LINOTYPE IMPROVEMENT INFORMATION SHEET

NO. 259

WISE JAW BEVEL PINION GUARD (UPPER) & (LOWER) (SELF QUADDER)

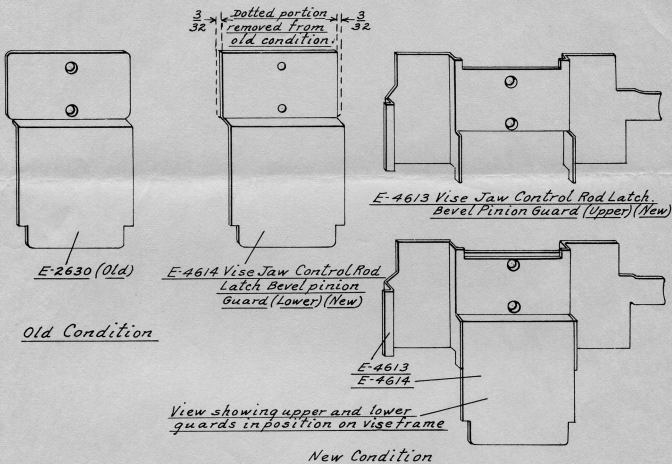
The vise jaw bevel pinion guard has been changed slightly and an additional guard has been provided to prevent matrices falling into and jamming the quadder mechanism and injuring the matrices.

Can be applied to outstanding 30 em machines, equipped with self quadder, by reworking upper part of old guard E-2630 to width of E-4614 as dimensions indicate and adding E-4613. The old screws are utilized to fasten the upper and lower guard to vise frame.
